**SUBJECT: Westinghouse AP1000 Design Control Document Revision 15 Errata**

1. APP-GW-GL-700, Revision 15, "AP1000 Design Control Document - Errata"
2. APP-GW-GL-700, Revision 15, Public View "AP1000 Design Control Document" (cd-rom)

**AP1000 Design Control Document**  
**Instructions for Inserting Revision 15 (Updated)**  
**Change Pages**

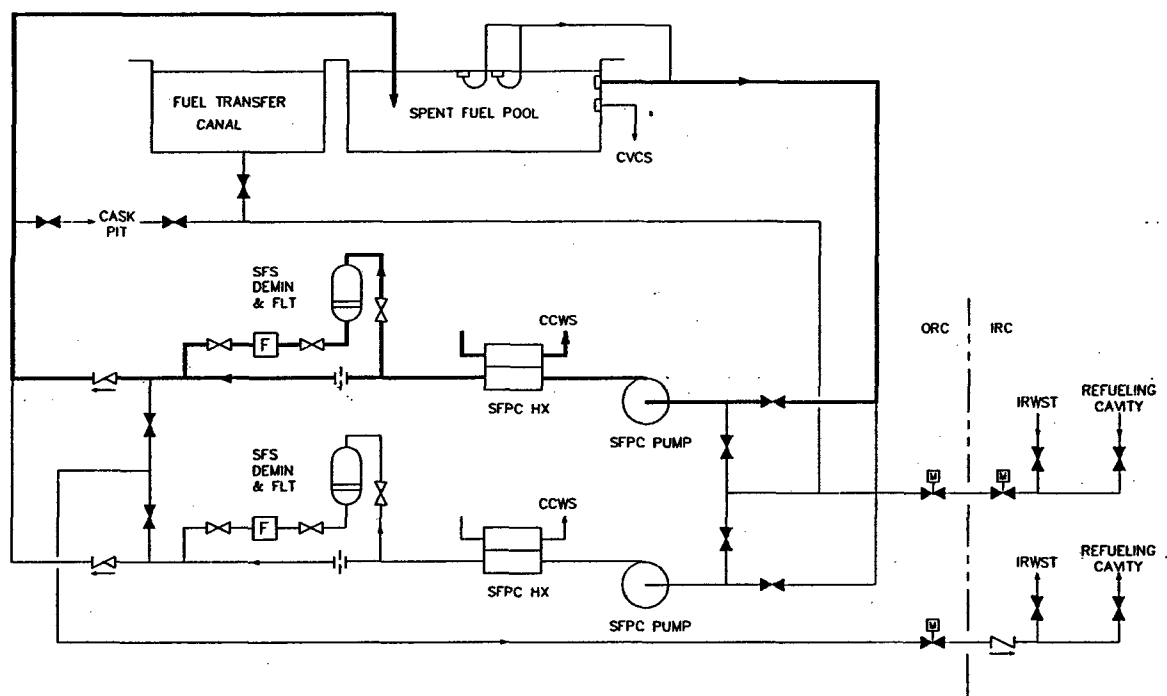
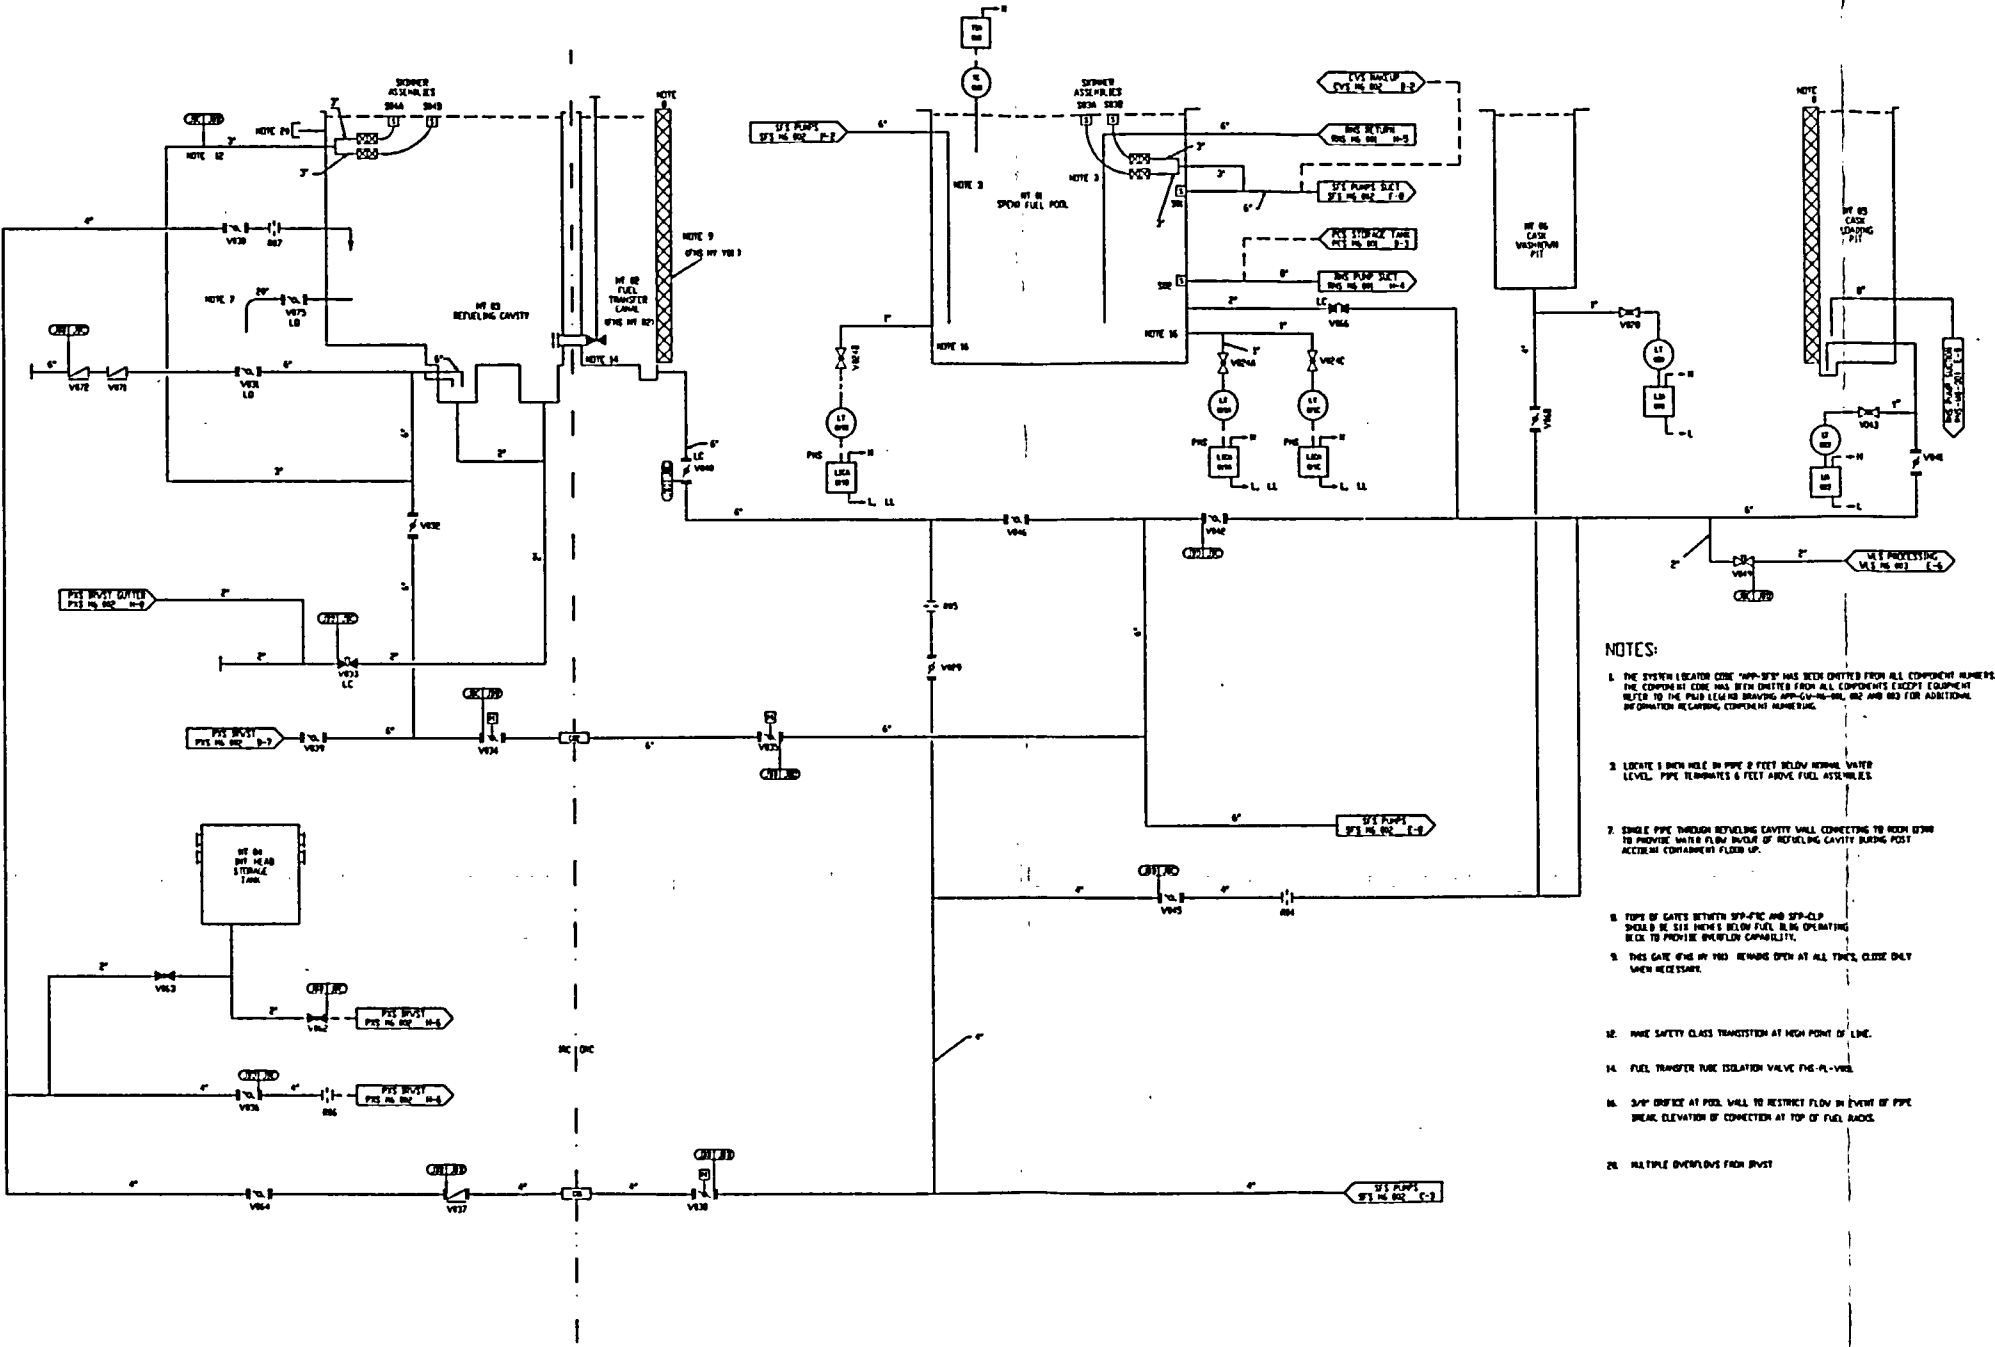
Gravity driven flow from the cask washdown pit to the spent fuel pool is provided as the cask washdown pit water level will follow the spent fuel pool level. Figures 9.1-5 and 9.1-6 show the connection of the cask washdown pit to the spent fuel pool.

Figure 9.1-6 (Sheet 1 of 2)

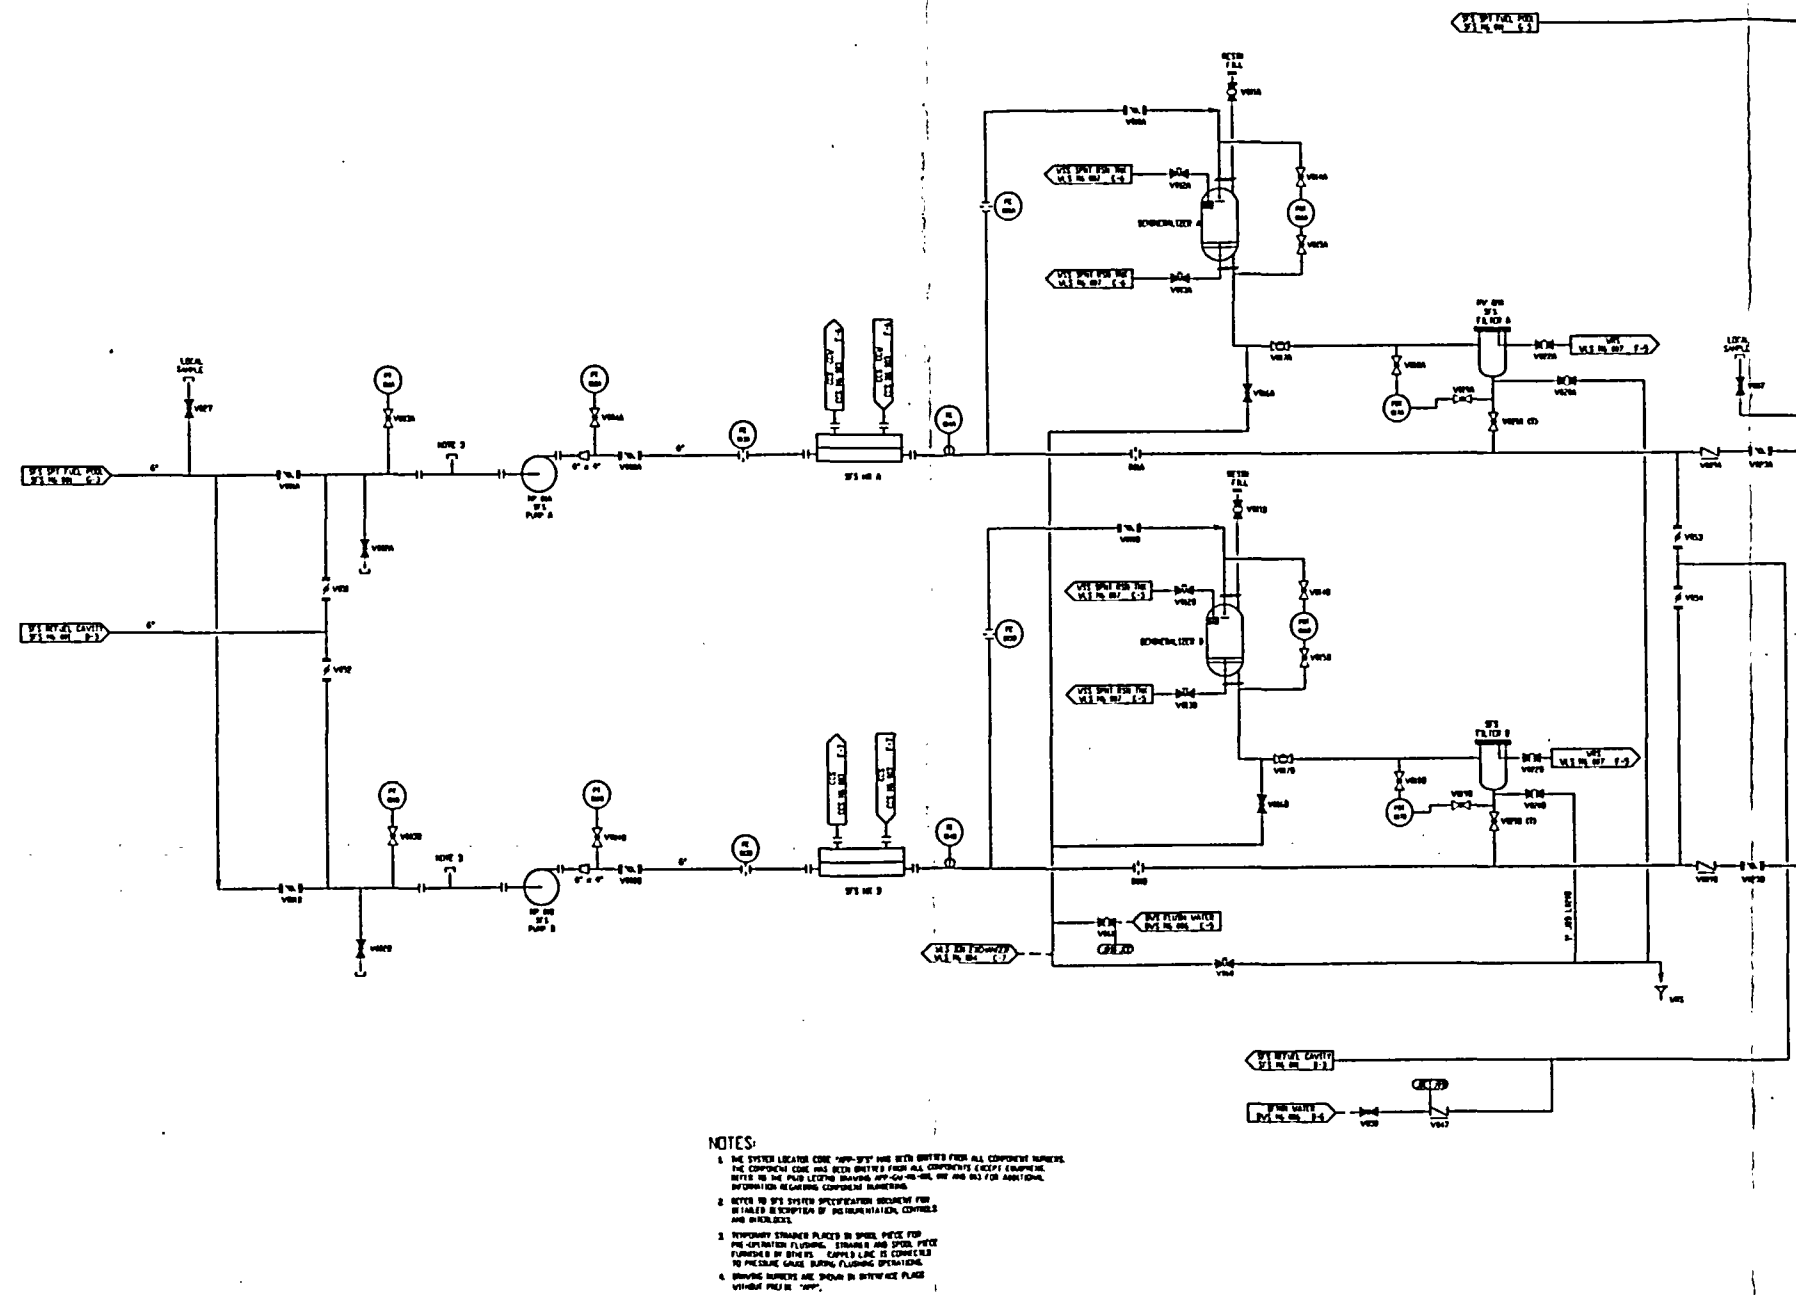
Gravity driven flow from the passive containment cooling water storage tank is controlled by a manual throttle valve with local flow indication which is set to achieve the desired flow when the makeup is initiated. Figure 6.2.2-1 shows the flow path from the passive containment cooling water storage tank leading to the spent fuel pool and the tie-in to the spent fuel pool is also shown in Figure 9.1-6.
